## PLANNING COMMISSION STAFF REPORT

### VILLAS AT MEADOWSIDE – DESIGN PLAN

**REQUEST:** Requesting approval from the Clermont County Planning Commission for Villas at Meadowside – Design Plan

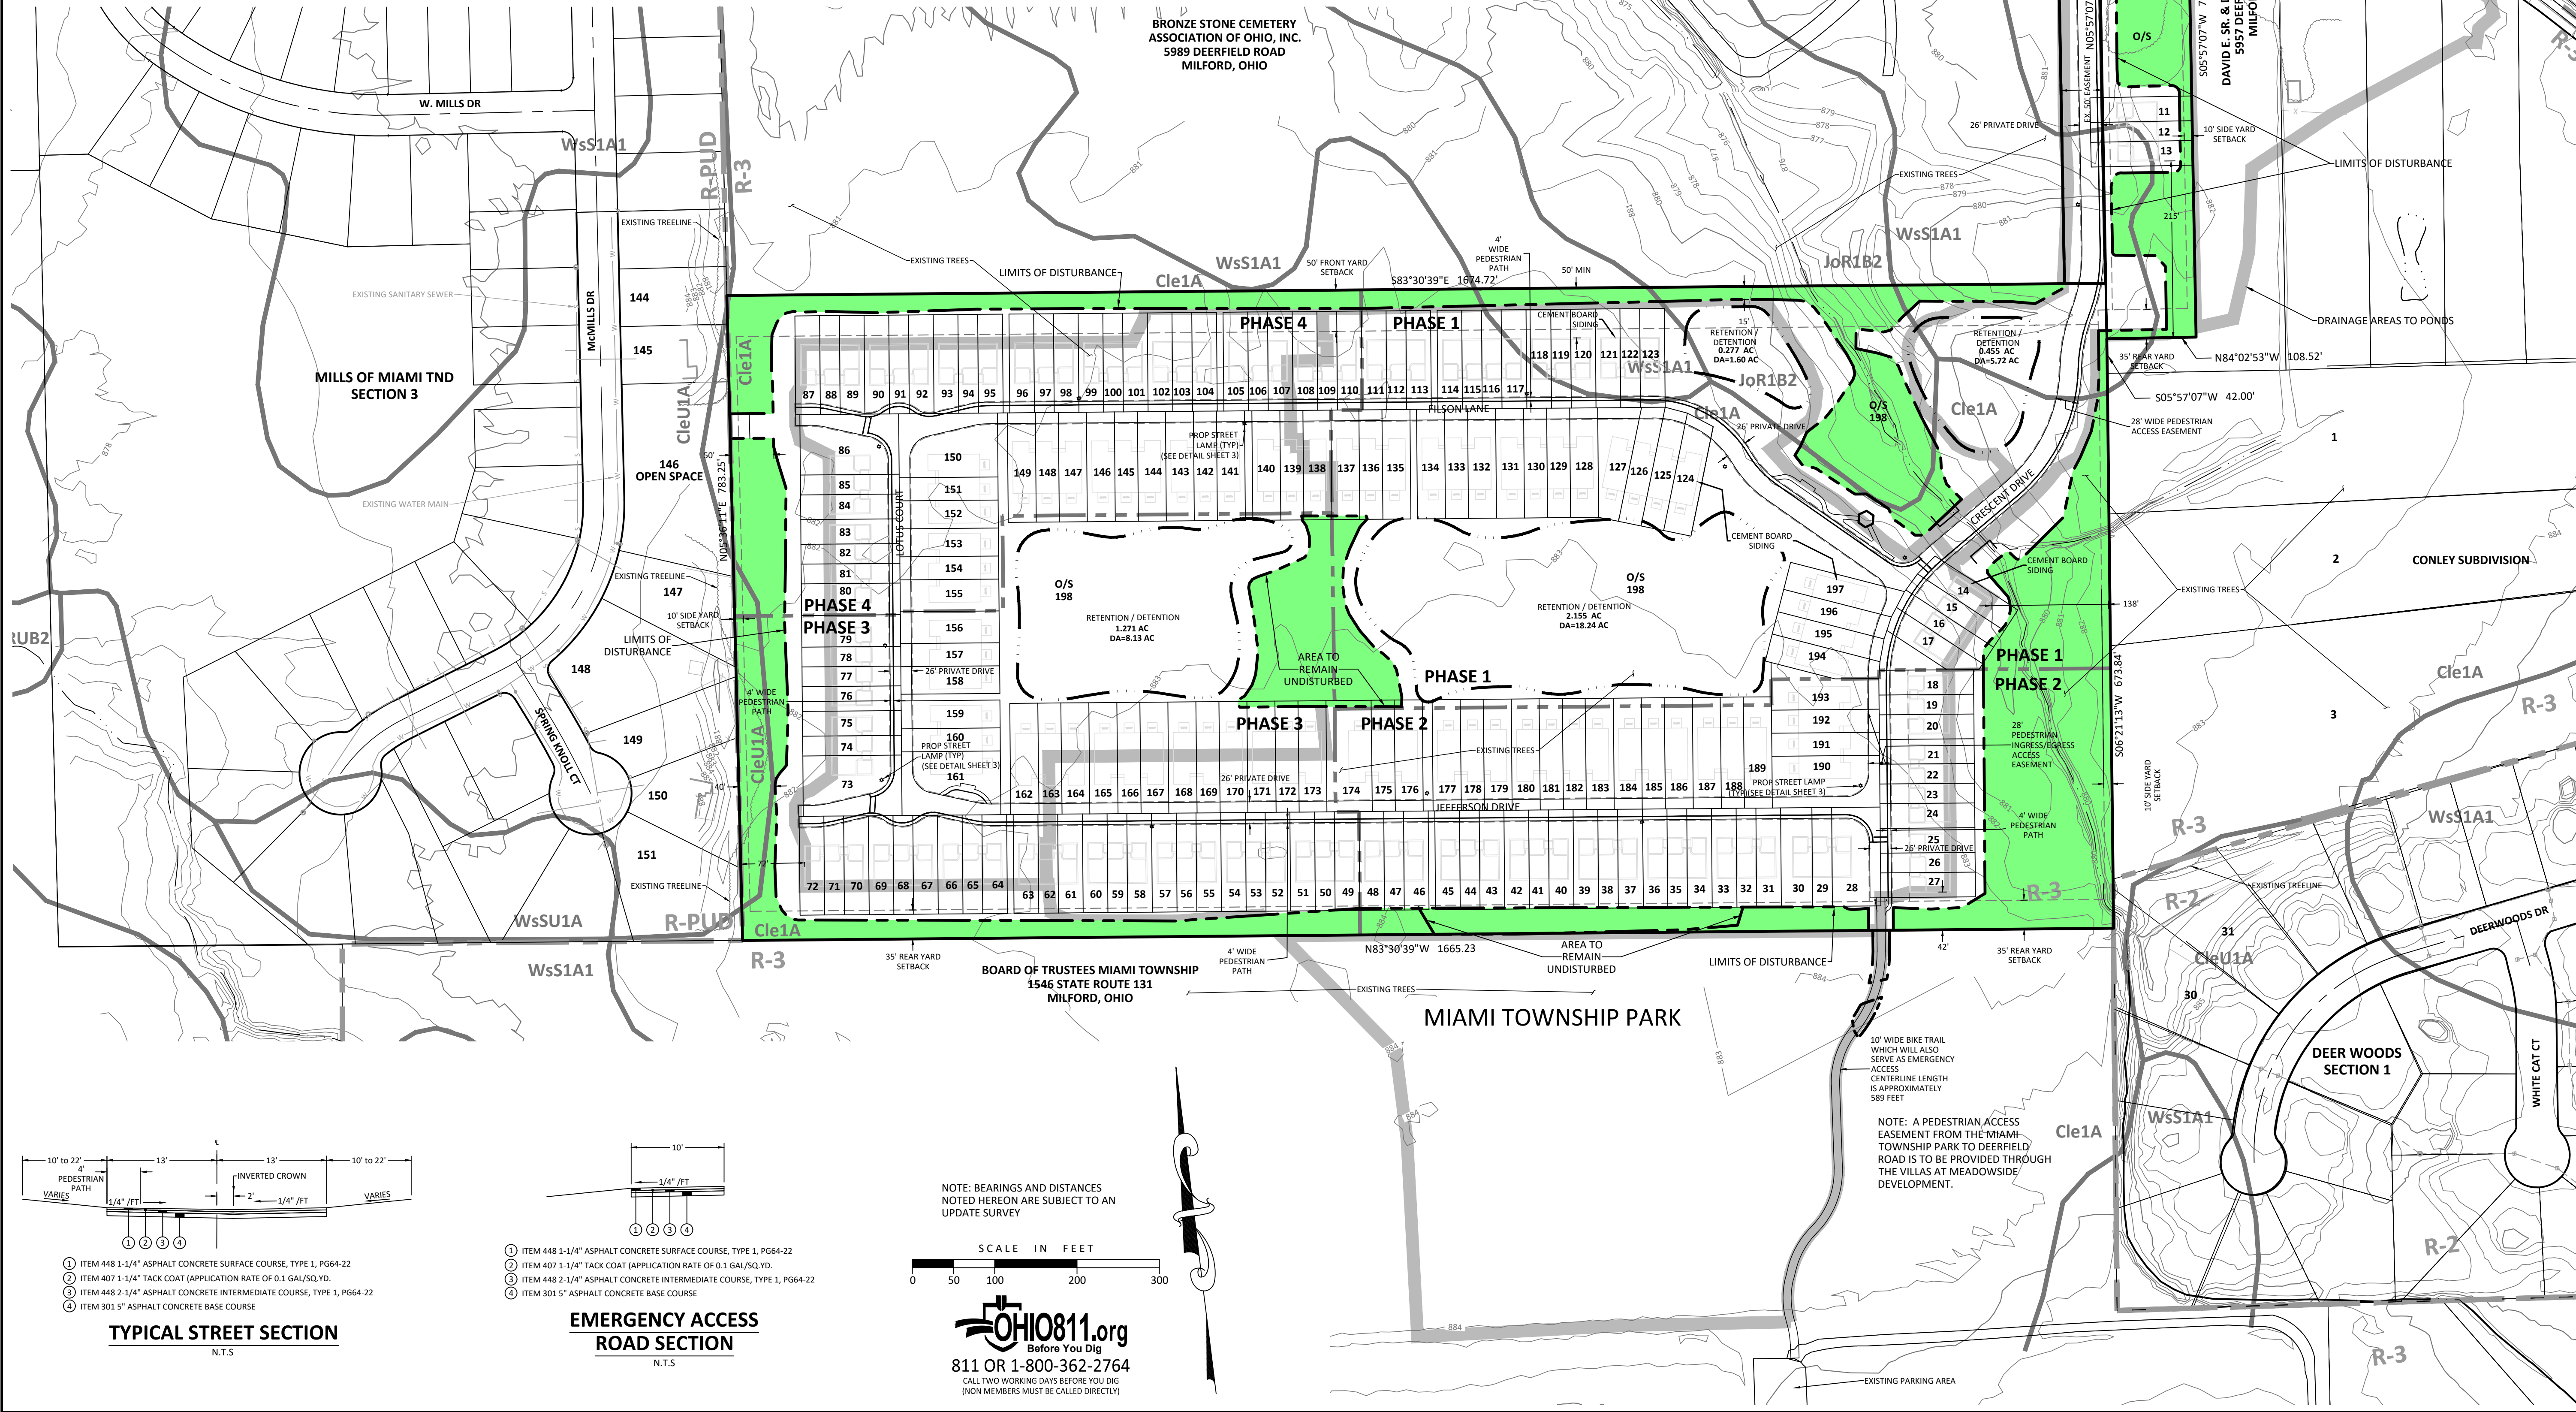
1. Sheet 1, Comment 7, Sanitary Sewer does not currently have sanitary sewer capacity on Deerfield Road.
2. Provide Profile Sheets of the water and Sanitary sewer with material, slope, and size.
3. Provide all necessary Rules & Regulations, Specifications and Details that apply to Water Resources.
